Title: Oktava MC/MK-012		
Oktava MC/MK-012 ZAPNSPARK		
Designed by:	Document N: 0001	Revision: 2.9
Checked by: JG 16:10:15	Date: 2010-06-04	Size: A
Approved by: JG 16:10:15	Sheet 1 of 1

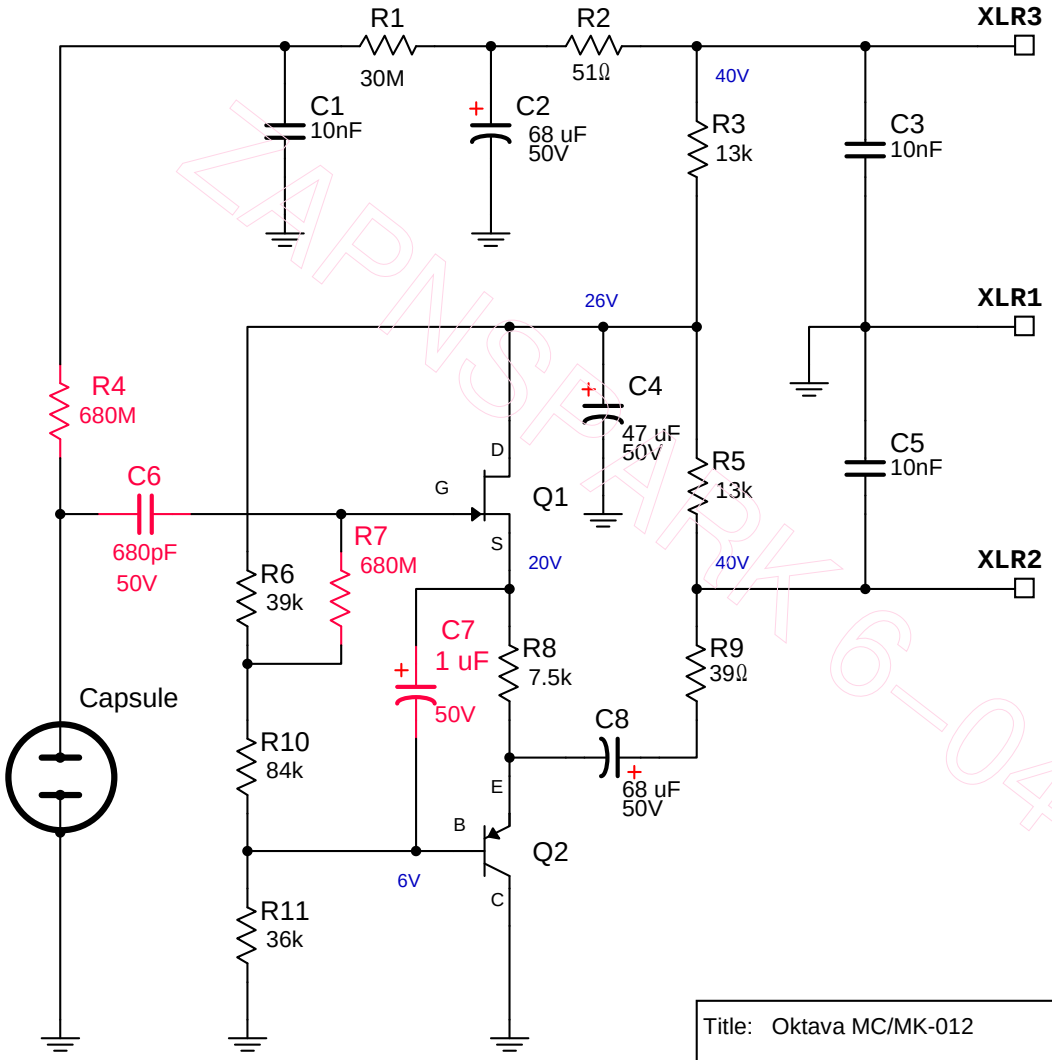
Suggested Modifications:
R4 & R7 = 1G or 2G metal film resistors
C6 = 1 nF 50V plastic film
C7 = 1 uF 50V small size plastic film
